UNITED STATES PATENT AND TRADEMARK OFFICE

APPLICATION NO.	FILING DATE	FIRST NAMED INVENTOR	ATTORNEY DOCKET NO.	CONFIRMATION NO.
10/057,233	01/25/2002	Harold T. Couch	01-550	3039

Office Action Summary

Claims 1 and 5 are rejected under 35 U.S.C. 102(e) as being anticipated by St. Pierre et al., WO 00/17951.

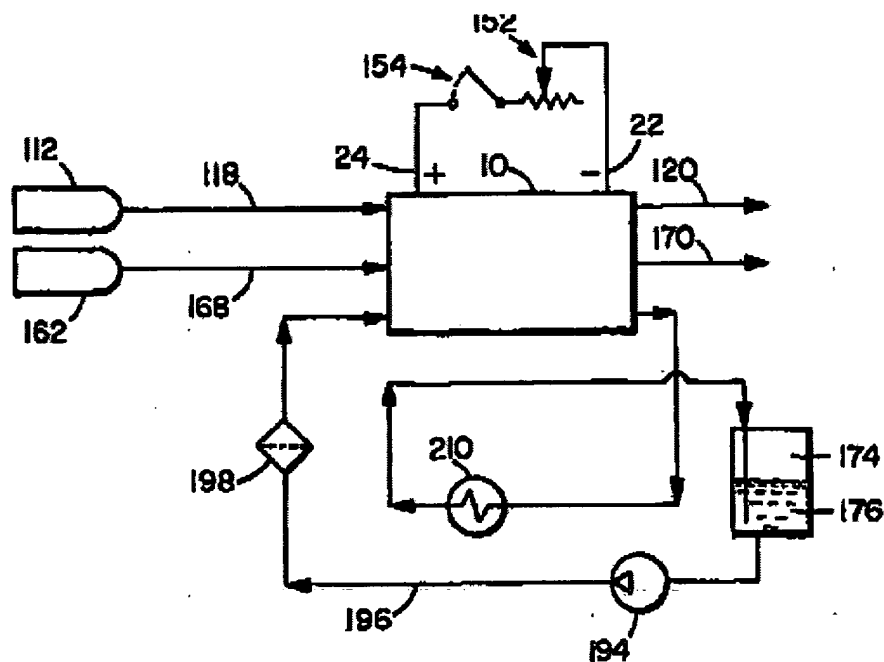
St. Pierre et al. disclose a fuel cell system which includes a cell stack assembly (10) with

a sump (174) containing water and glycol (176);

a heat exchanger (210);

a first feed means for feeding a heat source to the heat exchange (the output of the coolant loop from the fuel cell);

a second feed means (pump 194) for feeding antifreeze coolant (glycol) to the heat exchanger.

With regards to claim 5, when the pump is non-operational, it is a valve, since it stops fluid flow. Stopping the pump/valve stops fluid flow in the coolant loop, and thus the heat exchange is by-passed.

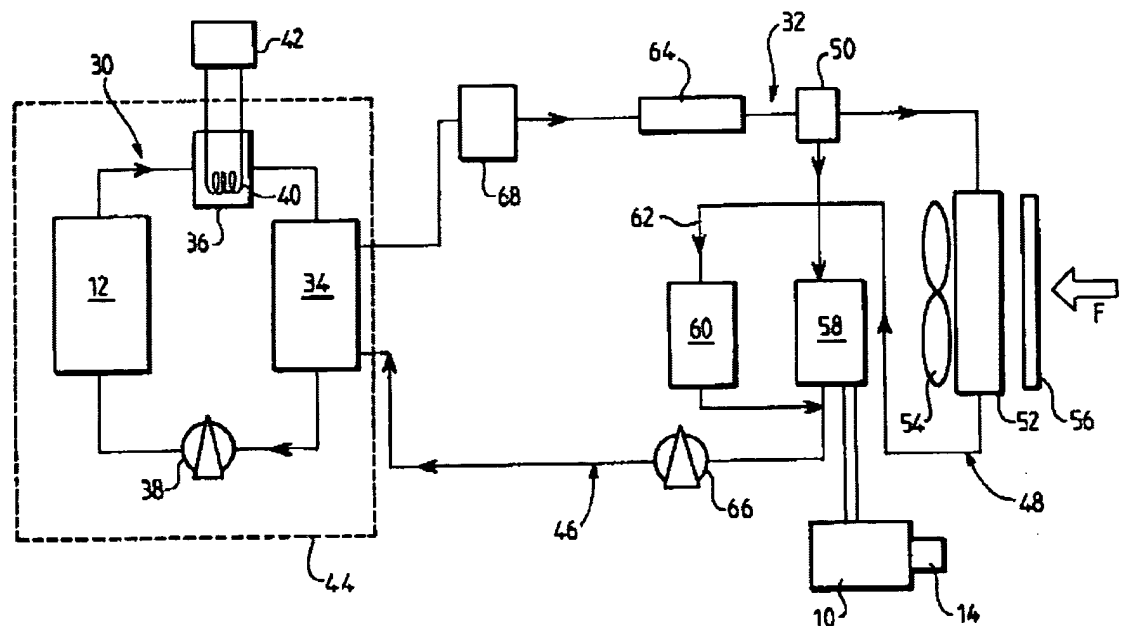
Claim 1 is rejected under 35 U.S.C. 102(e) as being anticipated by Ap, US
2002/0040896 A1.

Ap discloses a fuel cell system which includes
a fuel cell stack (12) having a sump or receptacle (36 and 68) containing water;
a heat exchange means (34);
a first feed means (pump 34) for feeding a heat source (output from heater 40) to
the heat exchanger;
a source of antifreeze coolant (coolant loop 32); and
a second feed means (pump 66) for feeding antifreeze coolant to the heat
exchanger and passing the heated antifreeze to the sump (68).
